**AL SHOFA WATER FACILITY
NASSRIYA, IRAQ**

**SIGIR PA-08-124
JULY 23, 2008**

SUBJECT: Report on Construction of the Al Shofa Water Facility, Nassriya, Iraq (Report
Number SIGIR PA-08-124)

Figure 1. Al Shofa Plan (Courtesy of the USACE)

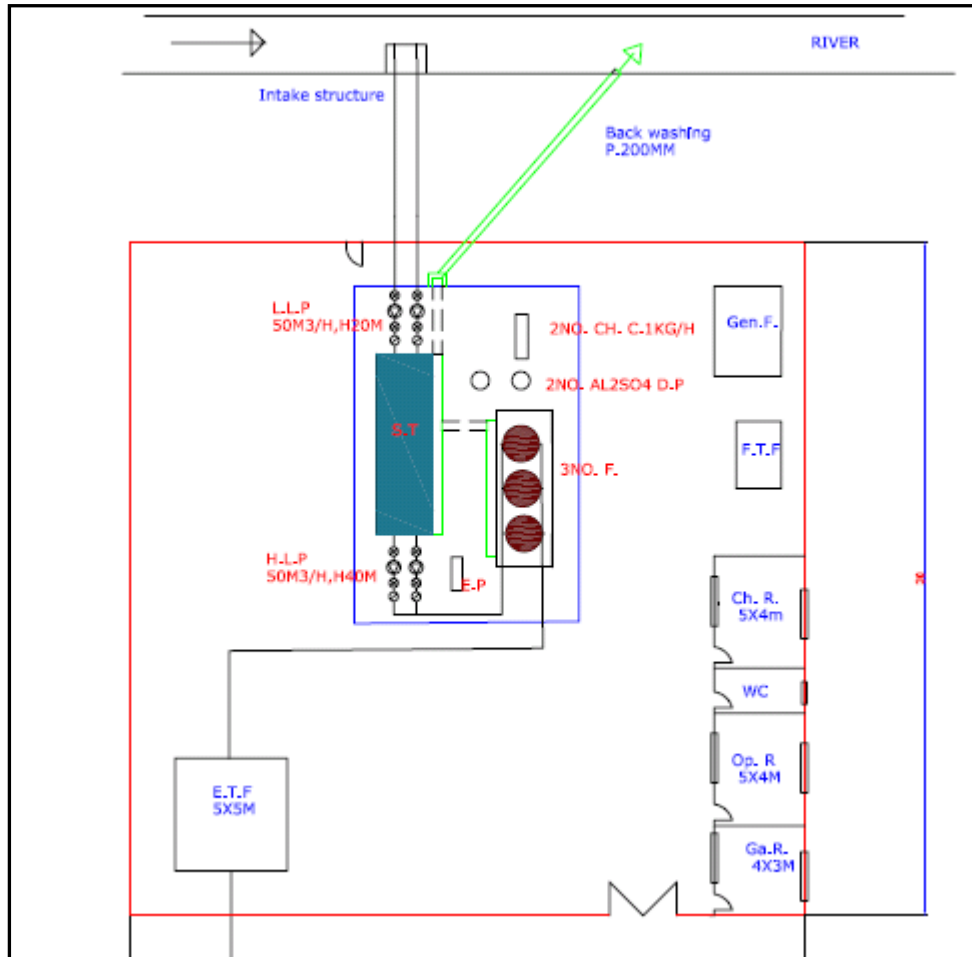
The USACE provided SIGIR with copies of the contractor's Al Shofa Water Facility project designs and specifications. The designs included the site layout (Figure 1), which provided the water compact unit layout and the building sizes. Also included in the contractor's design was the wall section design, which showed the expansion joint (Figure 2) and the cross-section of the wall (Figure 3).

After reviewing all available design drawings and specifications, SIGIR determined the design package was not complete and lacked sufficient details. Specifically, the designs did not provide any system overview detailing the process of raw river water entering the clarifier, being converted to drinking water, and then released to the end point (supply). In addition, the designs lacked necessary details, such as the sizes of pipes used, the potential need for pipe reducers, diameters for air and outlet nozzles for the high pressure filters, equipment lists, and diagram scales.

Further, the design package lacked architectural, civil, electrical, mechanical, and structural drawings for the chemical and operator buildings, and a foundation plan and conceptual layout of the elevated storage reservoir.

Figure 3. Al Shofa design layout (Courtesy of the USACE)

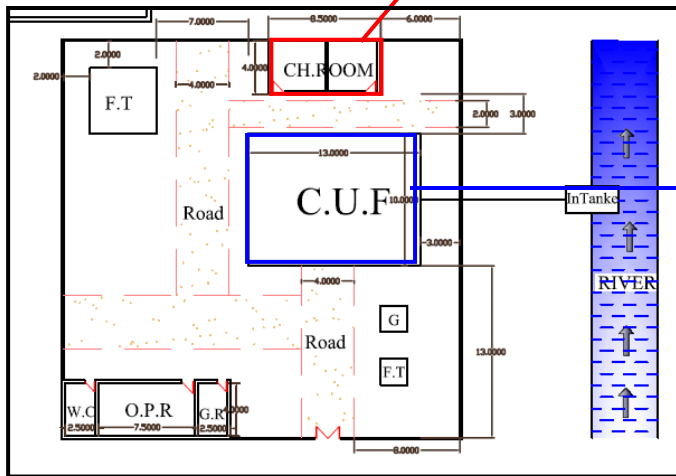
The contractor's site plan layout (Figure 4) included the following: elevated water tank, chemical building (Site Photo 10), water compact unit, operator building, light poles, and individual sunshades for the water compact unit, generator, and fuel tank.

At the time of our second site visit, the contractor had not completed the chemical and operator buildings, water compact unit, light poles, and the sunshade for the water compact unit. For example, electrical work was still required in both the chemical and operator buildings (Site Photo 9). In addition, the contractor had not installed the crane for the chemical building (Site Photo 11). The water compact unit sunshade and individual pieces of equipment still need to be bolted into the concrete slab (Site Photos 12 to 14).
